TYPE NO CV 7200	TYPE Coffe Vending Machines	T.I. NO 08 - 2015				
SERIAL NUMBERS AFFECTED From and including S/N 51611560		ISSUED BY Documentation/N&W Valbrembo				
SUBJECT 4TH CANISTER PRE-ARRANGEMENT AND KIT	ISSUED FOR (X):					
	<table border="1"> <tr> <td>Action</td> <td></td> </tr> <tr> <td>Information</td> <td>X</td> </tr> </table>		Action		Information	X
Action						
Information	X

4th instant canister location **COVER**

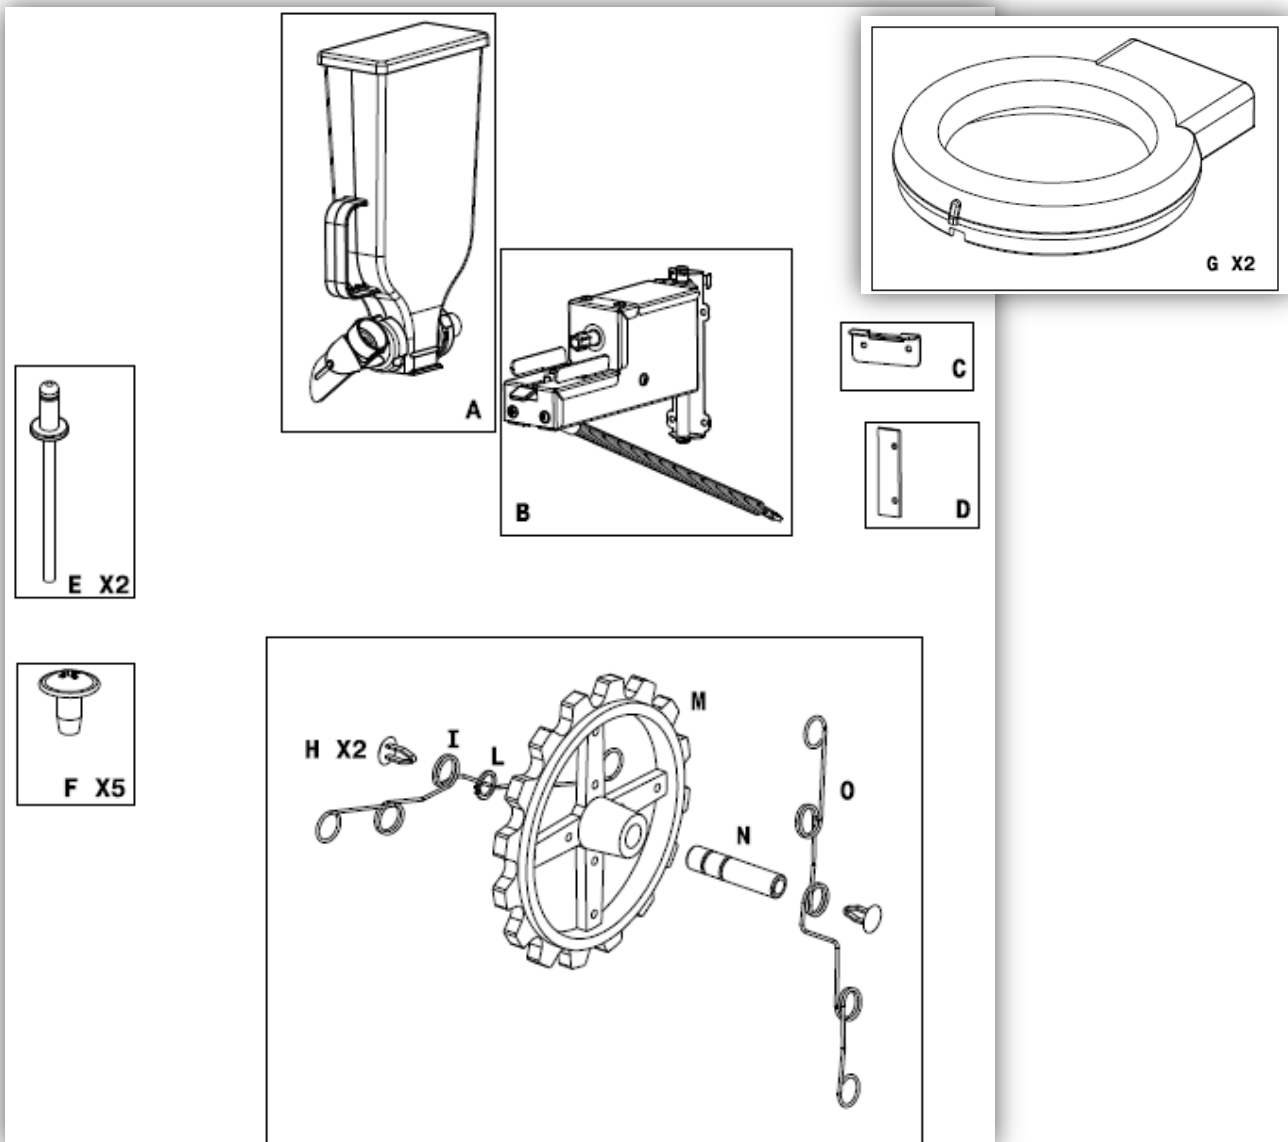
New CV 7200 lay-out: three instant canister with the cover (see photo below)

The machine is supplied with *4th instant canister* pre-arrangement, including the lateral cover and harness positioning behind it in order to plug & play the additional IN canister

The 4th instant canister location **COVER** spare part code is: **259623**
